Subject: WRD Comments on Proposed Plan for OU-2 Groundwater Contamination
Omega Chemical Superfund Site, Whittier, California

**Technical Memorandum
Omega Chemical Superfund Site
WorleyParsons
October 7, 2010**

**RE: TECHNICAL MEMORANDUM
 OMEGA CHEMICAL SUPERFUND SITE, WHITTIER, CALIFORNIA**

REFERENCE

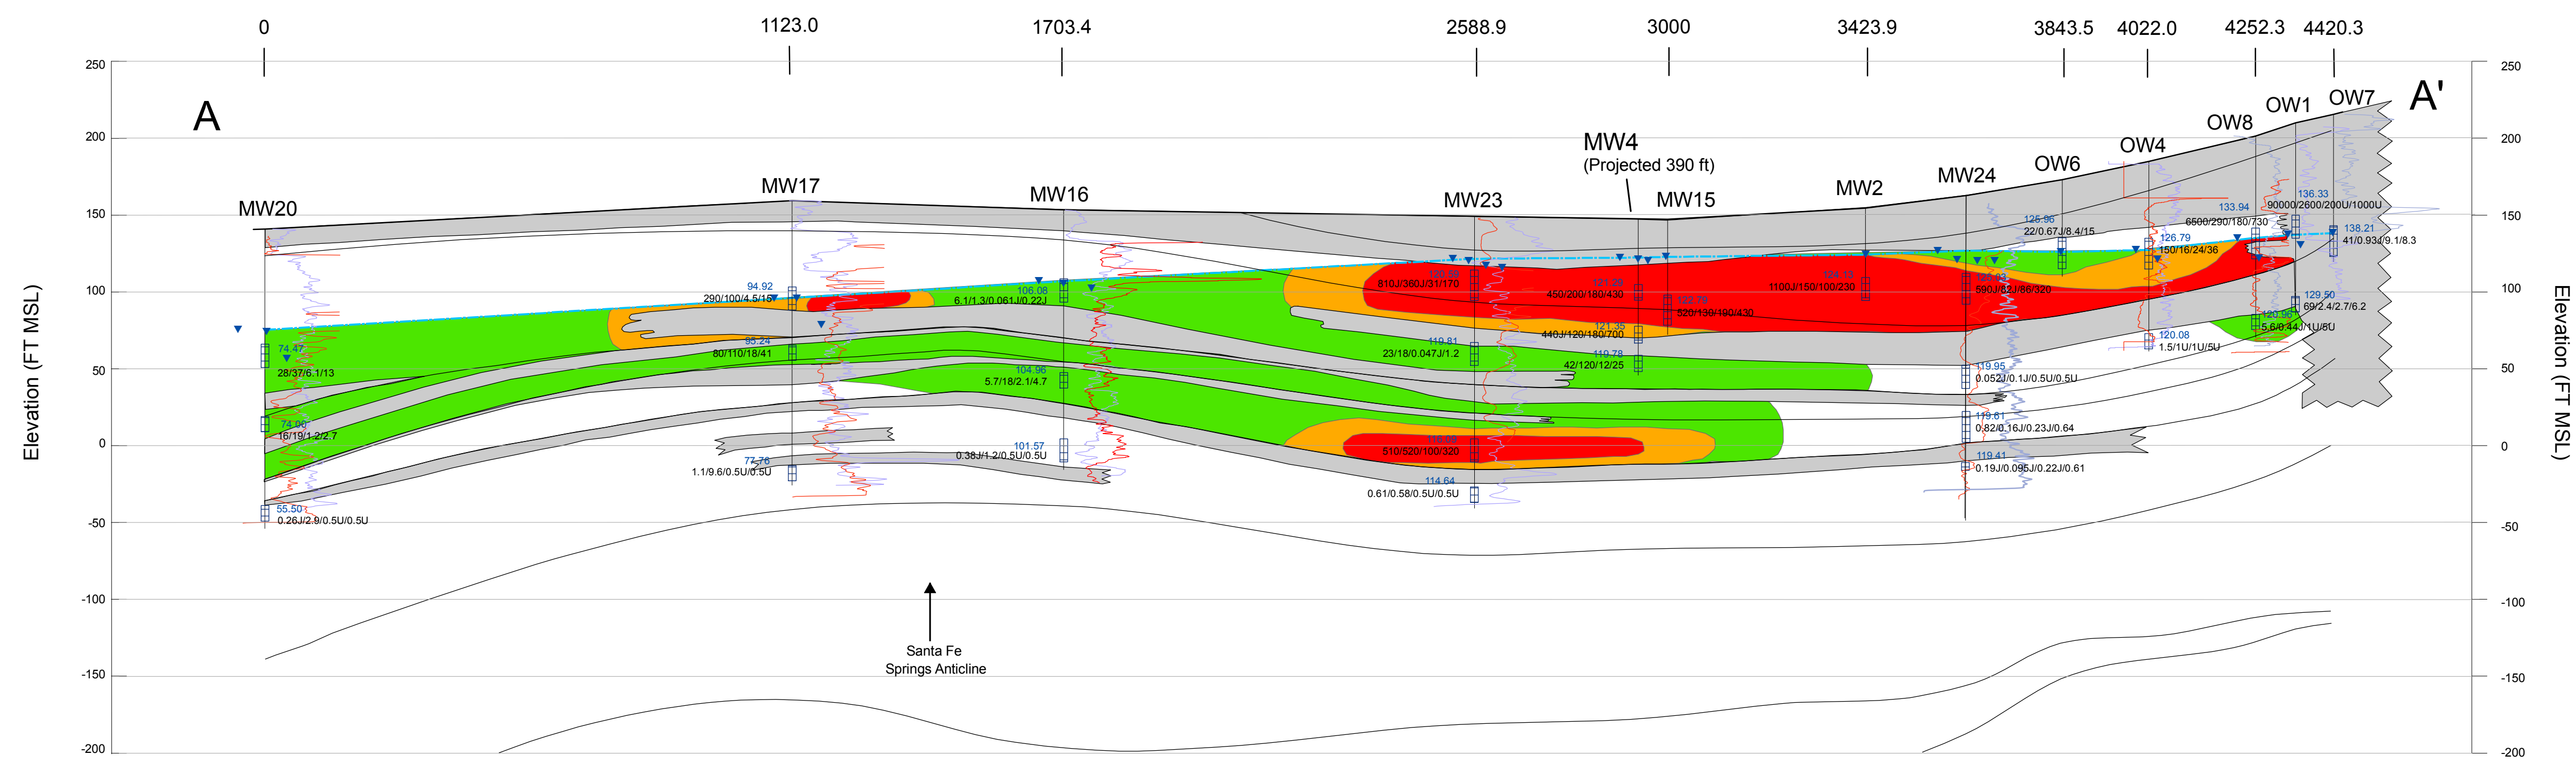
The vertical extent of contamination in the RI Report is likely under-represented (i.e., greater) in the downgradient part of OU2. The furthest downgradient monitoring well cluster with vertical delineation of the PCE or TCE plume is MW27; downgradient (south) of that well cluster, there is no vertical delineation of the plume. Figure 4-8 of the RI Report, cross-section C-C', shows the absence of

vertical delineation between MW27 and MW29. There are two key lines of evidence that indicate that contamination is likely deeper than indicated in the RI Report, as follows:
